STAFF REPORT

PLANNING & ZONING COMMISSION

Village Green Municipal Building, Council Chambers
47 Hall Street
Wednesday, April 13, 2016
7:00 P.M.

2008 Plan Back Building

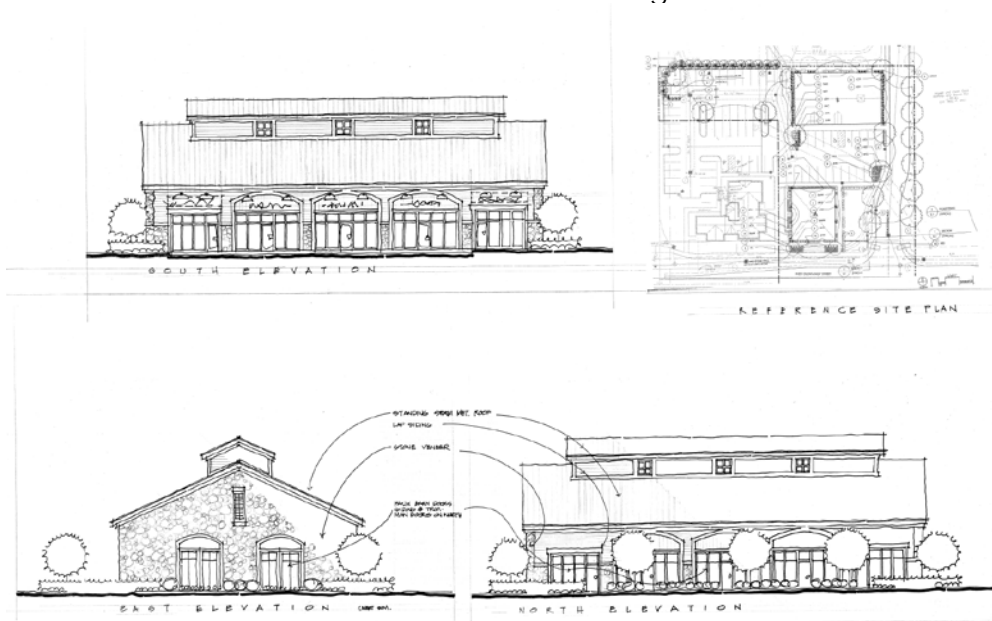
This property was subject to a development plan back in 2008 (see images below). Being over 5 years old that plan has expired. Now a new applicant has come forward with a revised development plan from that done in 2008.

Access to Village Pointe needed

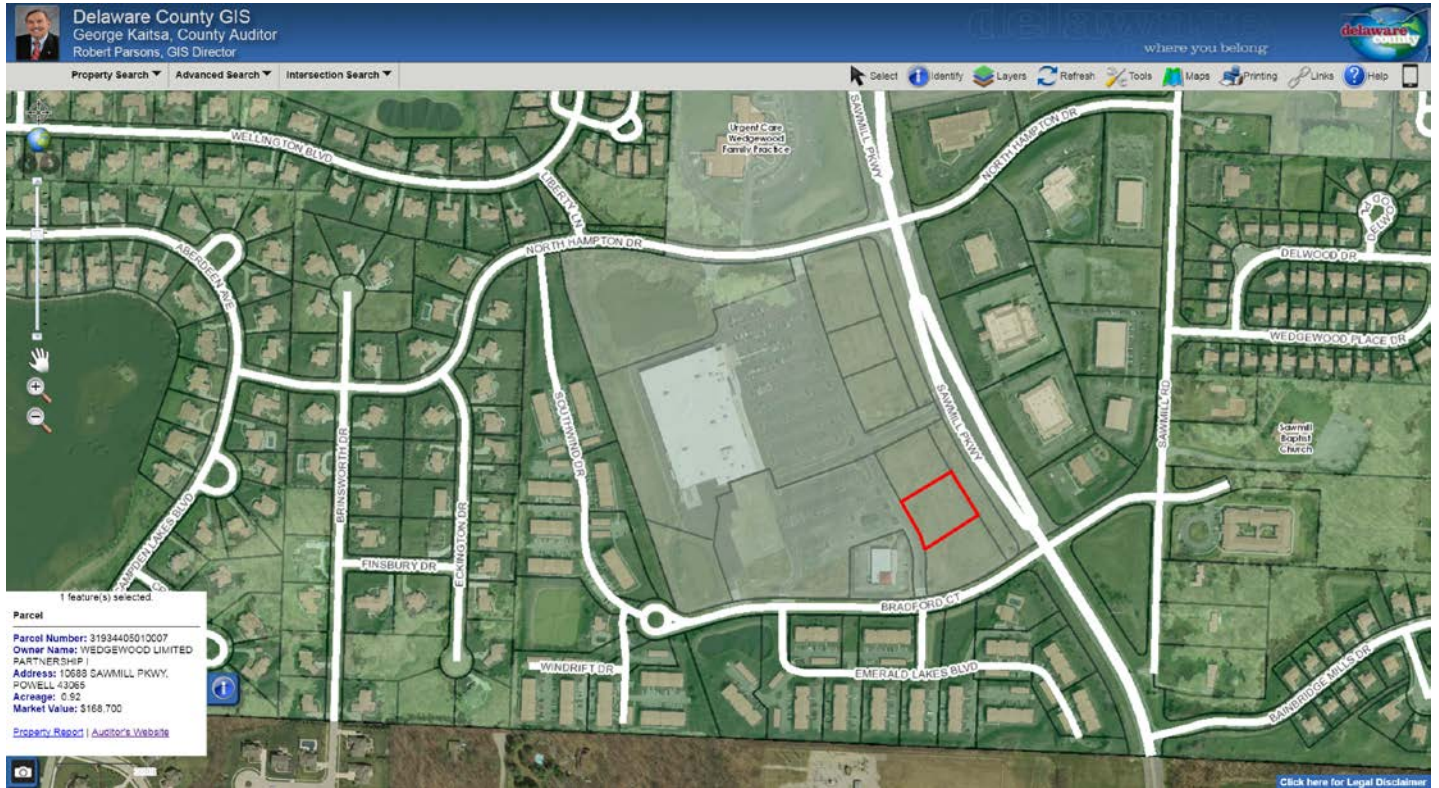
A commercial development such as this was always planned for this property. Staff is recommending that the applicant discuss cross access and parking agreements with all properties in this area, including the owner of Village Pointe (see below). By having access between all properties here, it provides needed linkages and complete parking allowances for everyone to benefit from.

Staff recommends that the above comments be taken into consideration and provided within the Preliminary Development Plan submittal.

Site Location: Red box above.

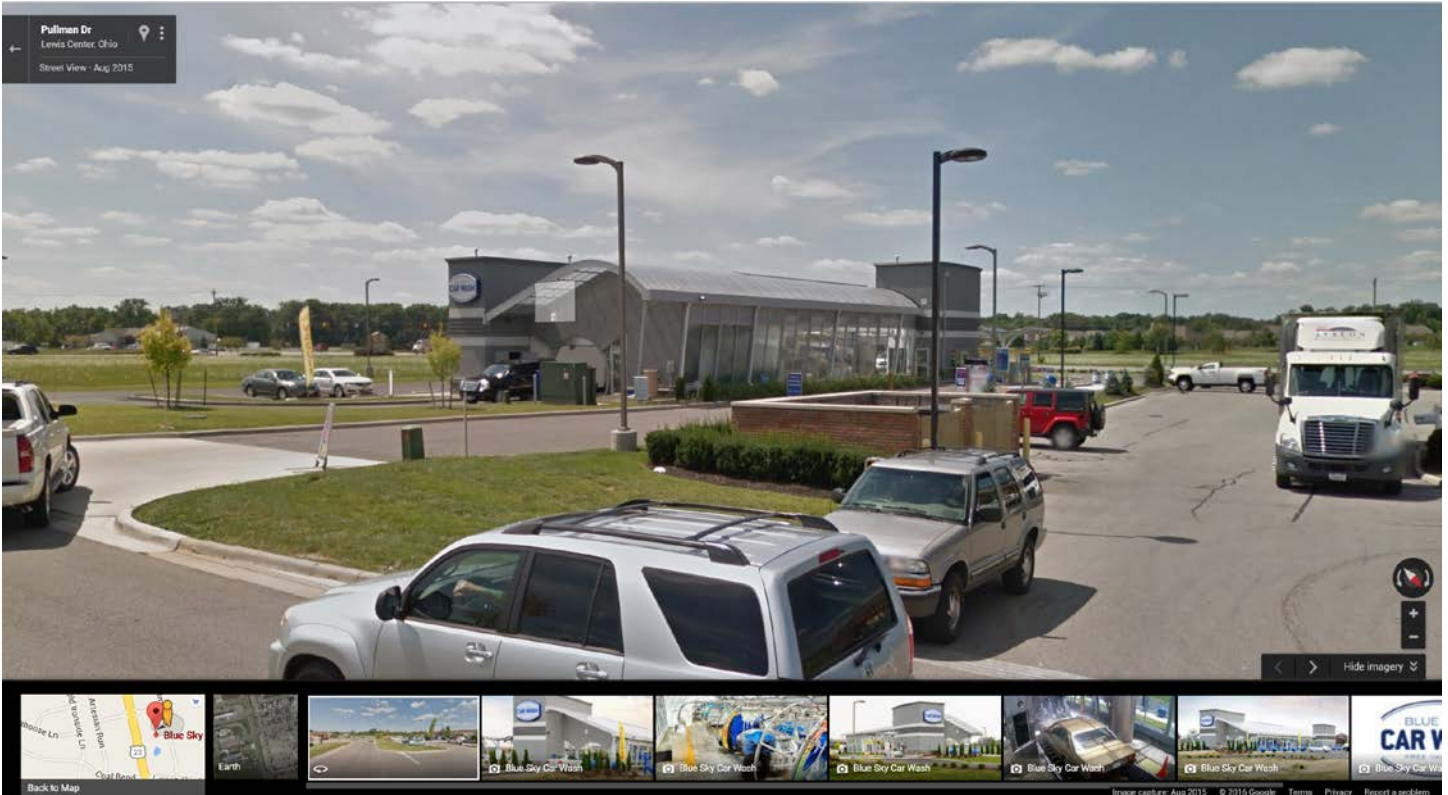
The photos below are from their Orange Township location on Route 23. The proposal here is going to be quite similar. Although the submitted color drawings show covered vacuum parking areas these are actually open. They also show a larger canopy which is not going to happen. What is being proposed is quite similar to the Orange Township location.

The applicant has also submitted a lighting plan that shows that the majority of the lighting spread will be at 0.5 foot candles or lower along the majority of the property line. Where it goes above, it is recommended that further light blocking screen be added to the back side of the parking lot light fixture.

- The use itself is a permitted use within the PC, Planned Commercial District and the approved Shoppes at Wedgewood plan approved by Liberty Township and annexed into the City.
- It appears as though all code requirements are met or can be met.
- The lighting plan does show some light transference over the property line. Extra deflectors can be utilized on the light fixtures at certain locations in order to solve that problem
- The landscaping is adequate to meet code but could be beefed up as this is a most intense use.

1. That the sign plan submitted meets code in terms of number and sizes of signs, and that all white background lighted signs have an opaque white with translucent colored letters.
2. The lighting plan be revised to reduce the lumens in places showing over 0.5 Foot candles.
3. That, if possible, the applicant provide more landscaping.
